**STATE OF TENNESSEE
DEPARTMENT OF TRANSPORTATION
DESIGN DIVISION**

INSTRUCTIONAL BULLETIN NO. 14-05

Regarding Revised Standard Drawings

Effective for the August 29th Letting (June 18th turn-in), the following Standard Drawings are revised and Section V of the Design Guidelines is revised for this update.

CONTROLLER CABINET DETAILS

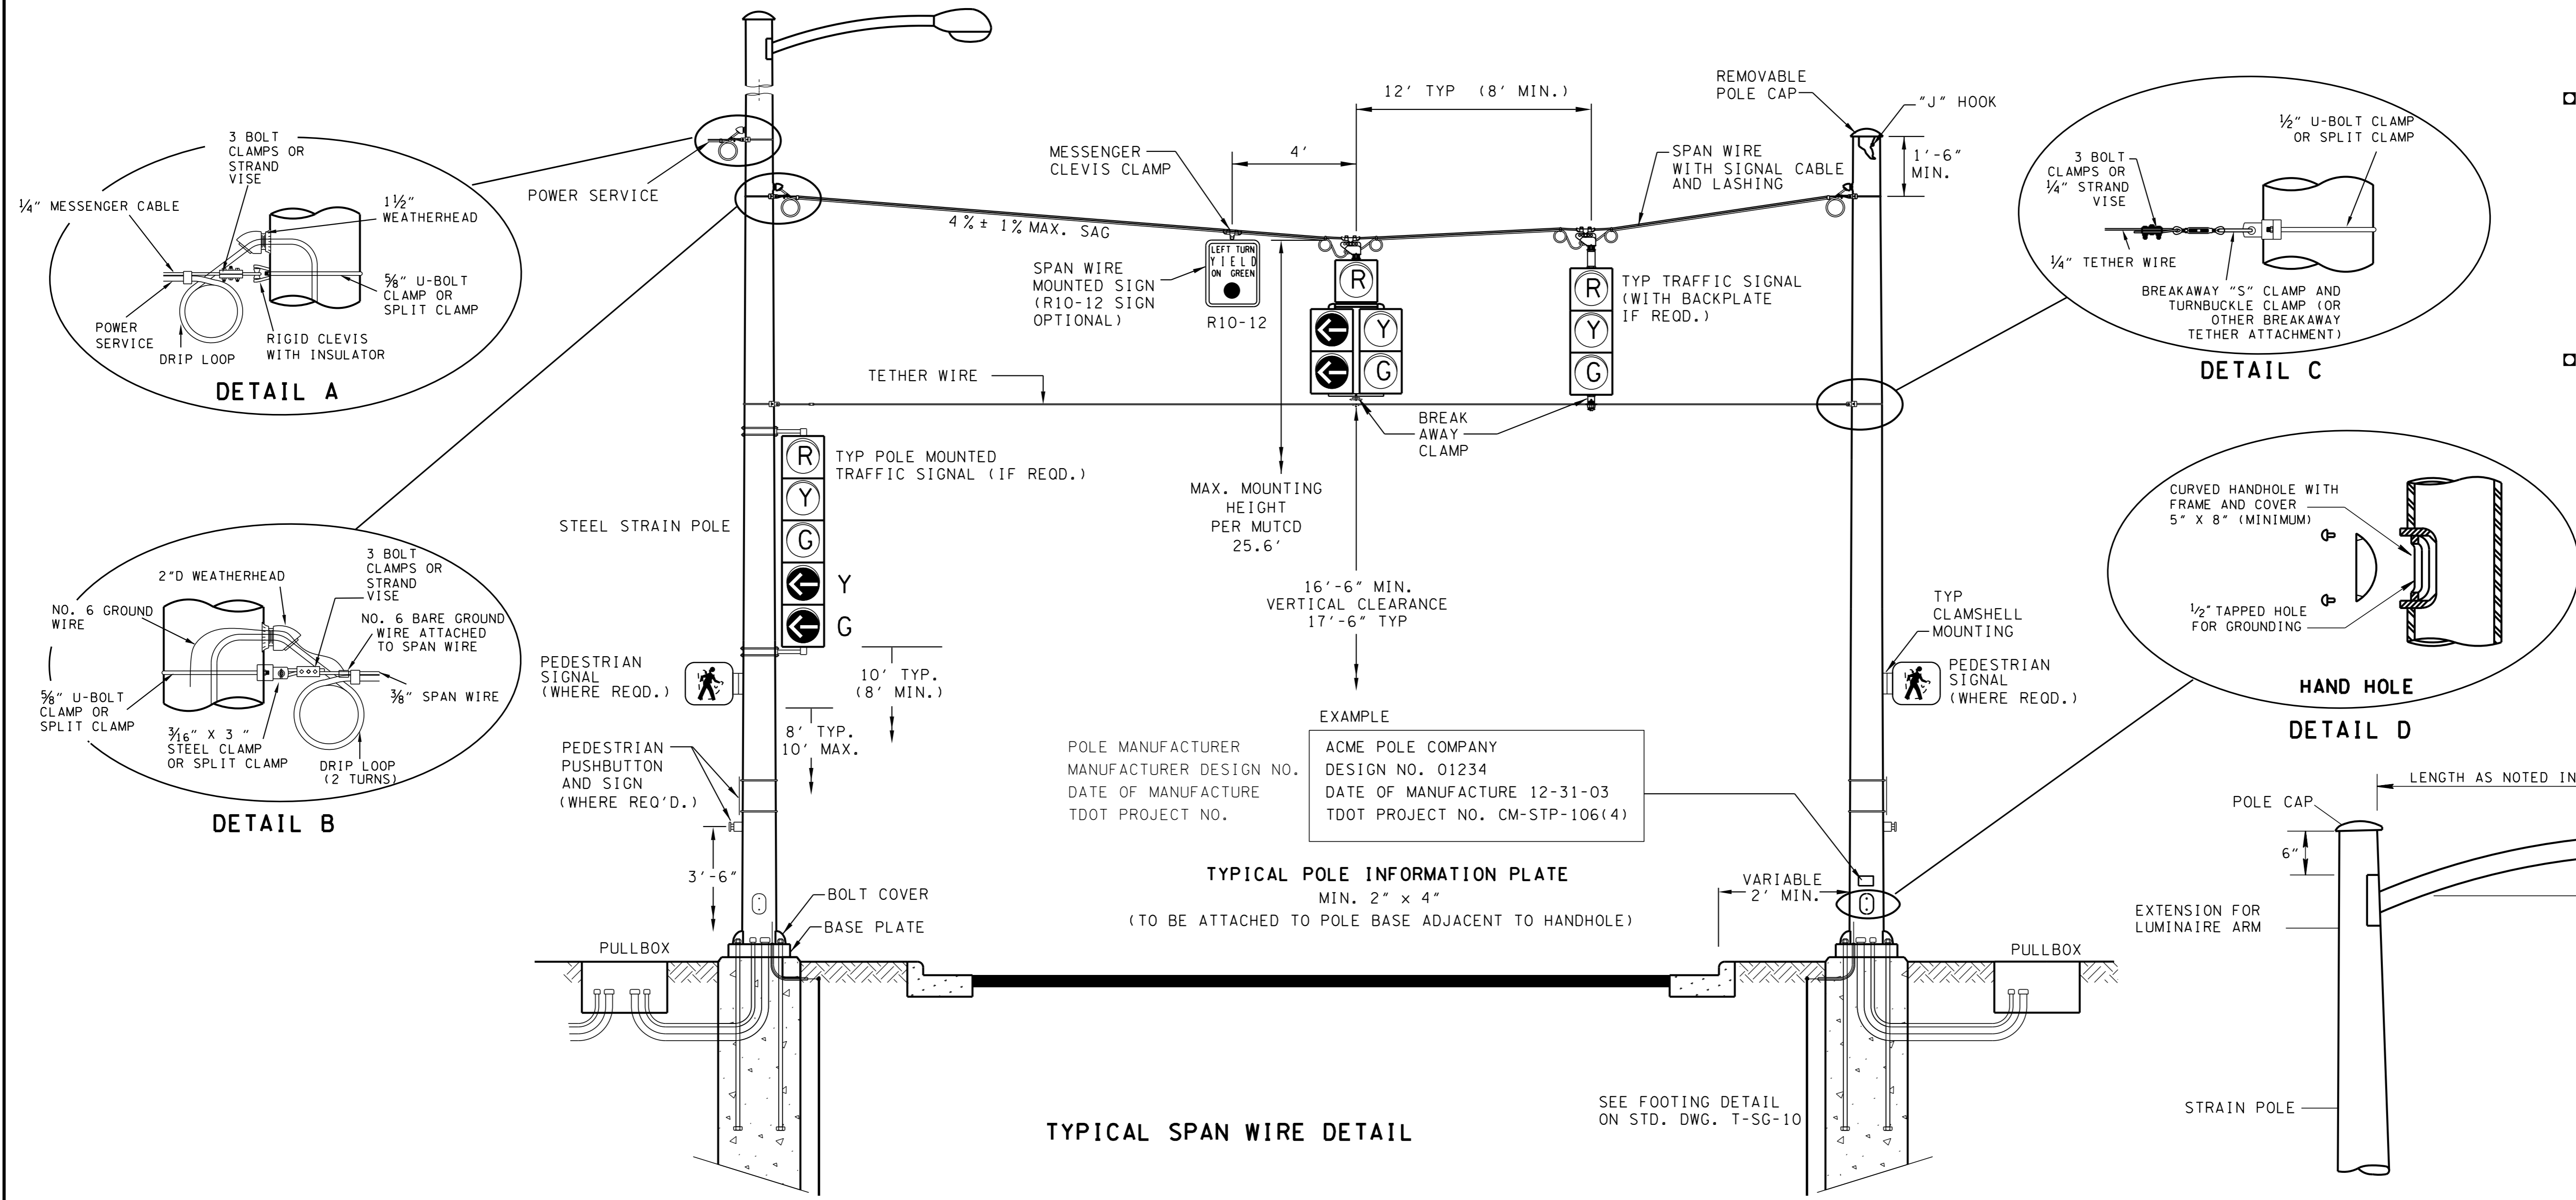
- REV. 6-7-72: ADDED NOTE CONCERNING POLE MOUNTED CABINETS.
- REV. 7-1-72: CHANGED DEPARTMENT NAME.
- REV. 1-1-76: CHANGED DWG. NO. FROM TR-S-4 TO T-SG-5.
- REV. 4-12-85: REVISED NOTE UNDER APPROX. CAB. DIM. ADDED DETAIL FOR MOUNTING BRACKET.
- REV. 7-29-96: REDREW SHEET ON CADD AND MADE MINOR CHANGES.
- REV. 12-16-03.: REDREW SHEET. DELETED TYPE 1-V CABINET AND ADDED NEW DETAILS FOR POLE AND BASE MOUNTED CABINETS.
- REV. 7-29-04: REDREW, AND REDESIGNED SHEET.
- REV. 12-4-13: CHANGED ANCHOR BOLTS TO THREADED.

STANDARD LIGHTING
FOUNDATION
DETAILS

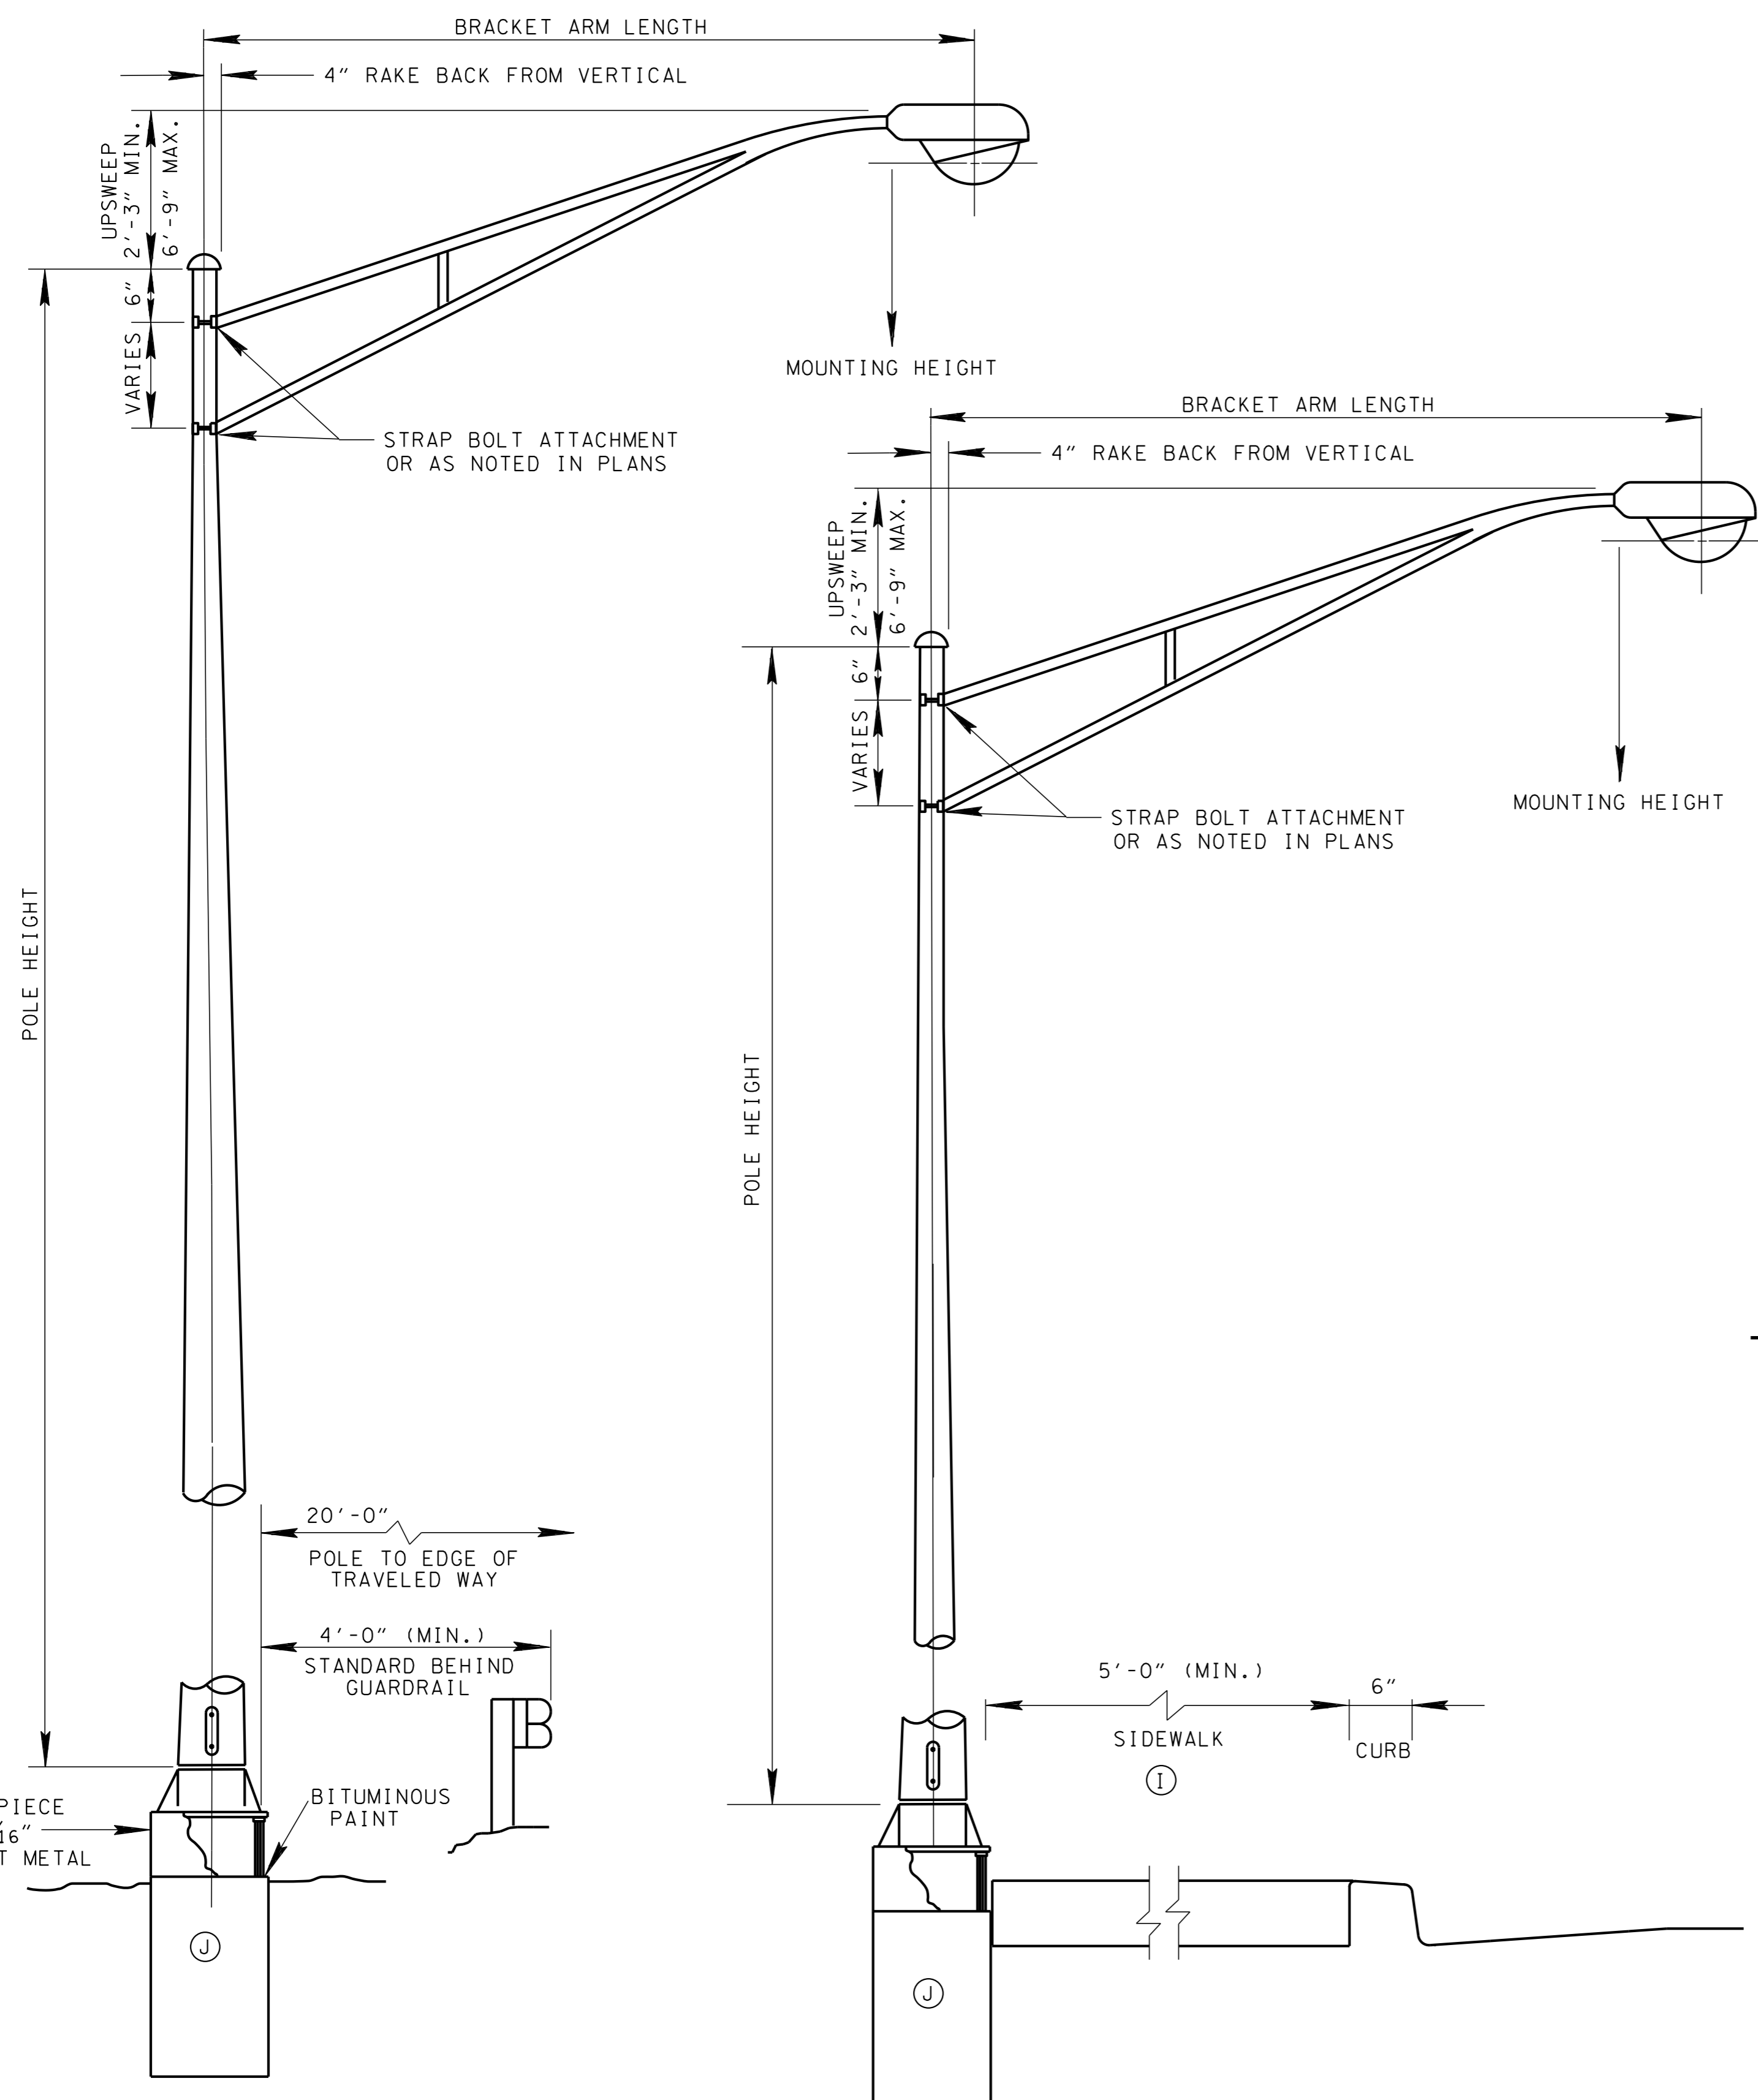
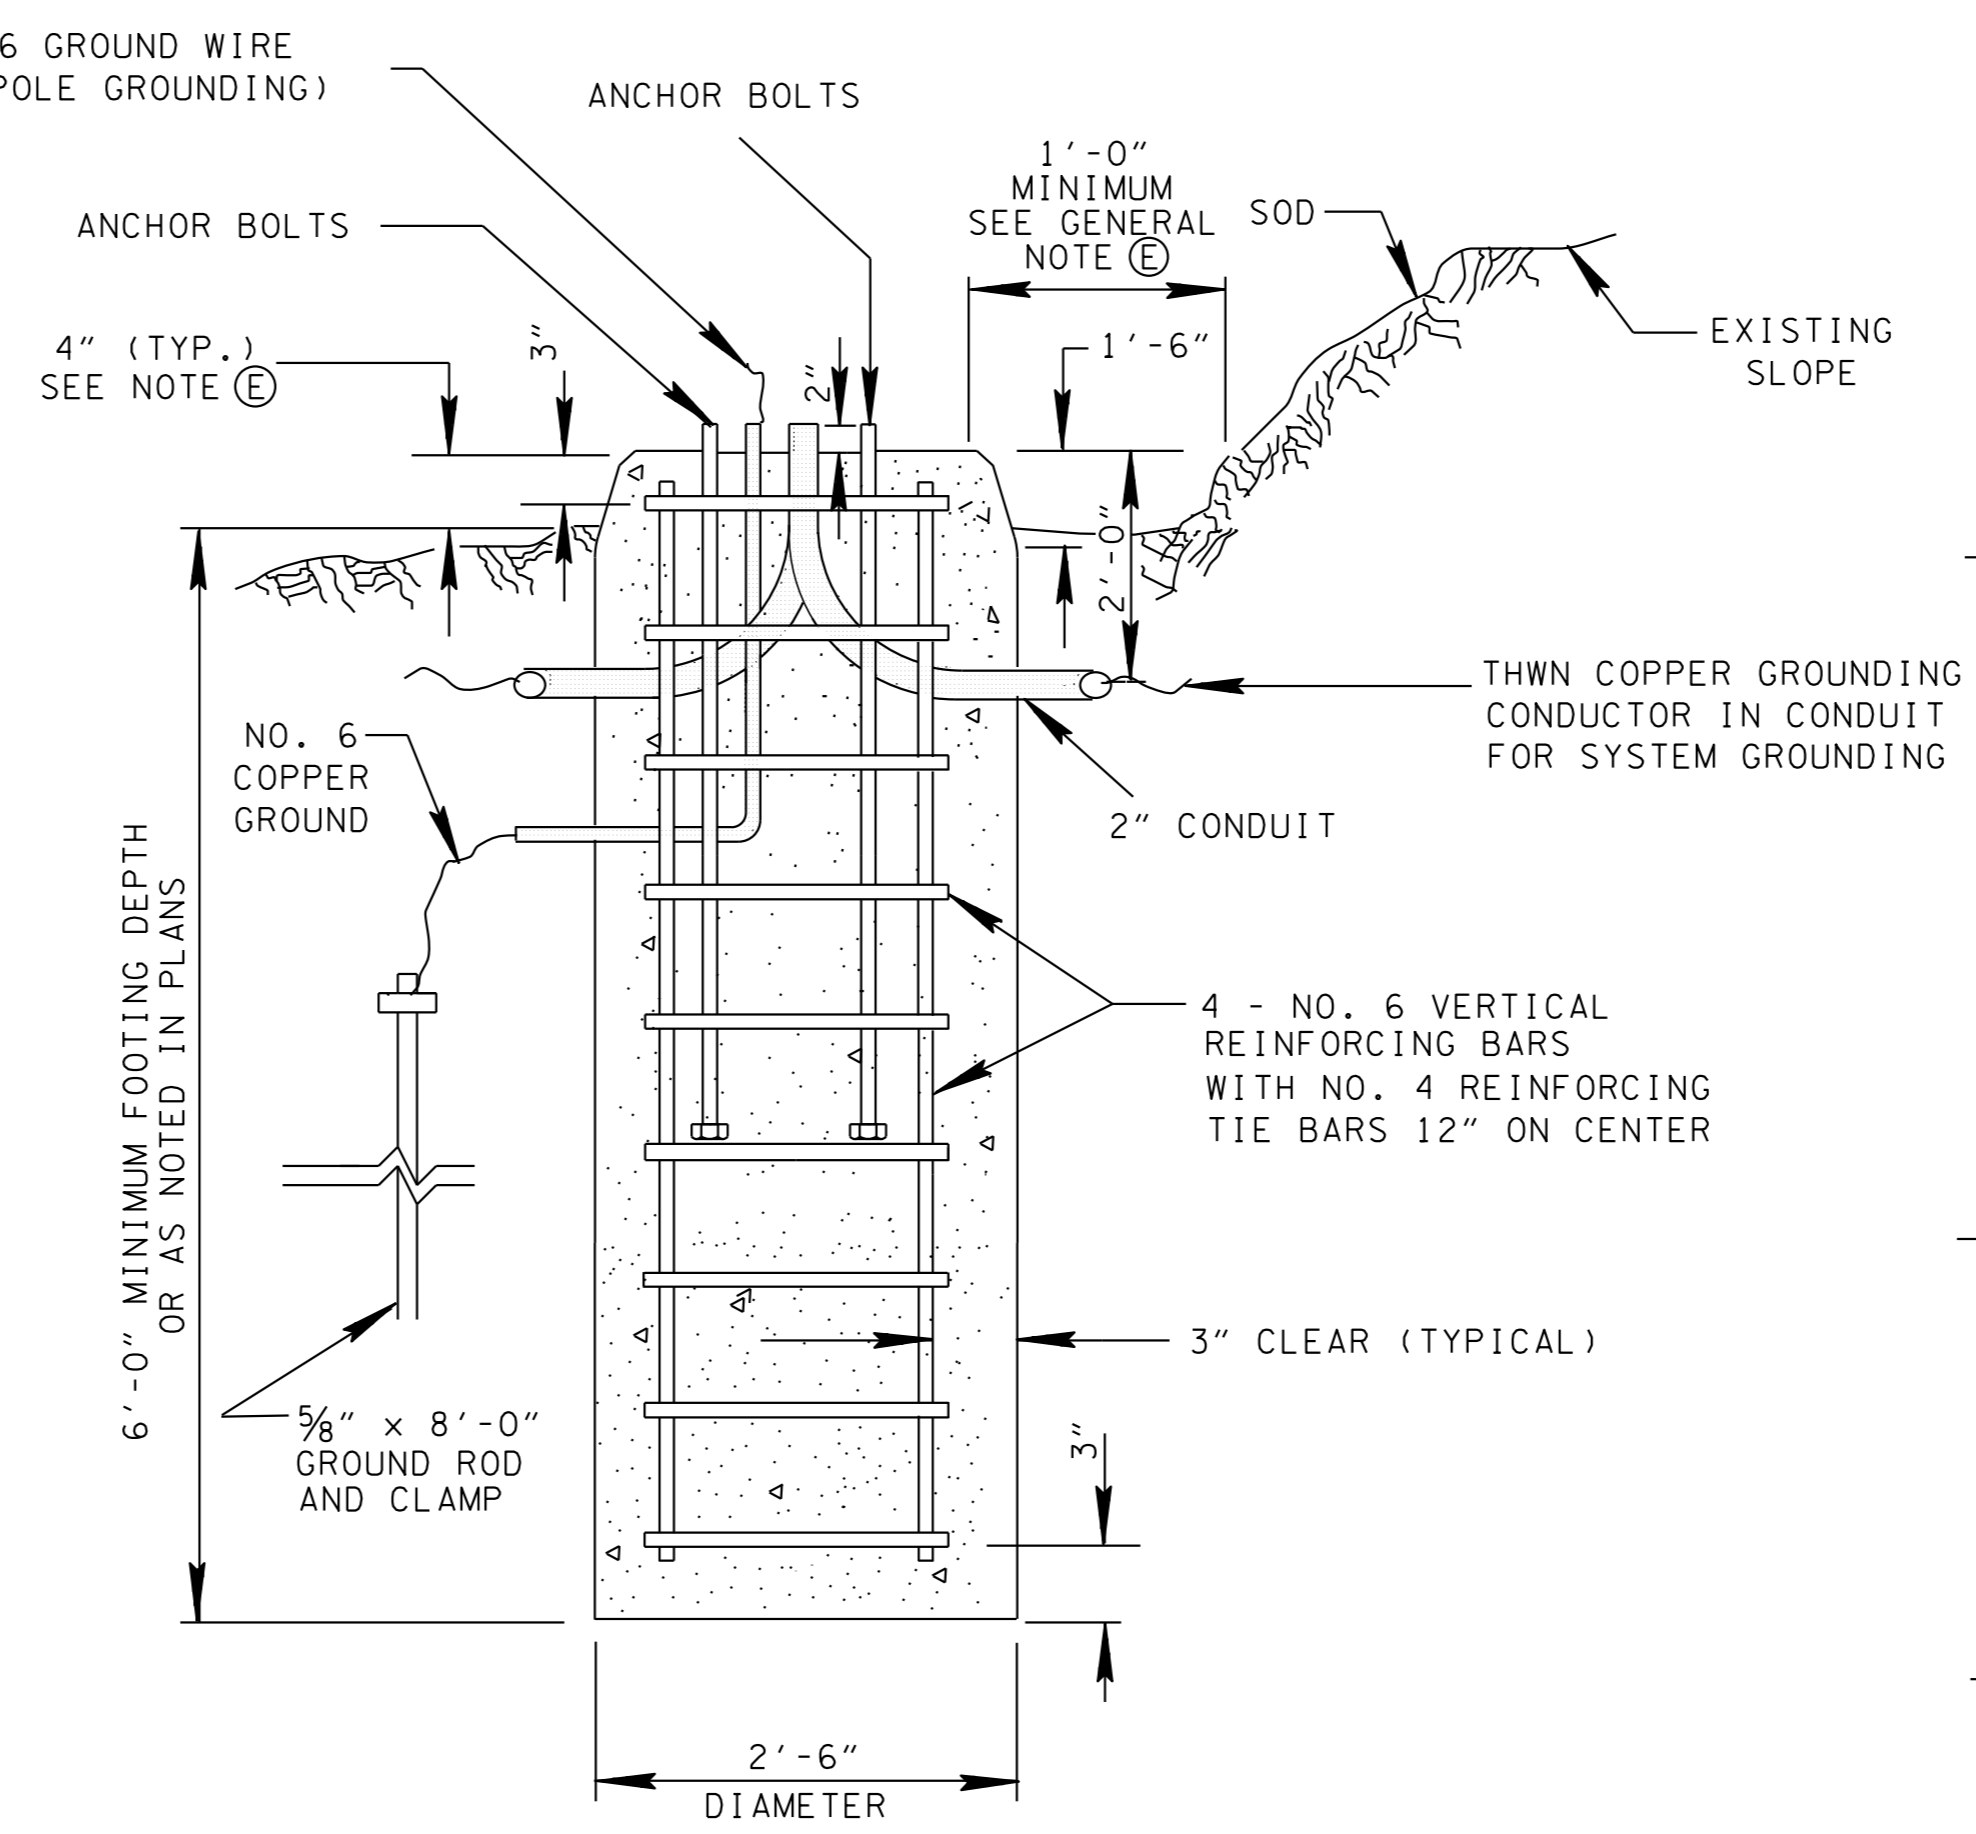
- REV. 11-12-93: NEW SHEET TRANSFERRED INFORMATION FROM T-L-1. ADDED METAL FOUNDATION DETAIL ALTERNATE.
- REV. 5-27-94: ADDED TABLE FOR HIGH MAST FOOTING AND GROUNDING CONDUCTOR SIZE.
- REV. 10-26-95: MODIFIED DESCRIPTION OF REINFORCING STEEL. CHANGED SIZE OF GROUND ROD ON HIGH MAST FOUNDATION DETAIL.
- REV. 12-16-03: DELETED GROUNDING CONDUCTOR CHART. ADDED NOTE E.
- REV. 7-29-04: CHANGED DRAWING NO. FROM T-L-1A TO T-L-1. ADDED GENERAL NOTE (E) DELETED GROUNDING CONDUCTOR SIZE TABLE.
- REV. 02-15-07: ADDED ANCHOR BOLT DETAIL. NOTES AND NOTE (E) AND (F) ADDED.
- REV. 12-4-13: CHANGED ANCHOR BOLTS TO THREADED. ADDED BEARING AREA TABLE.
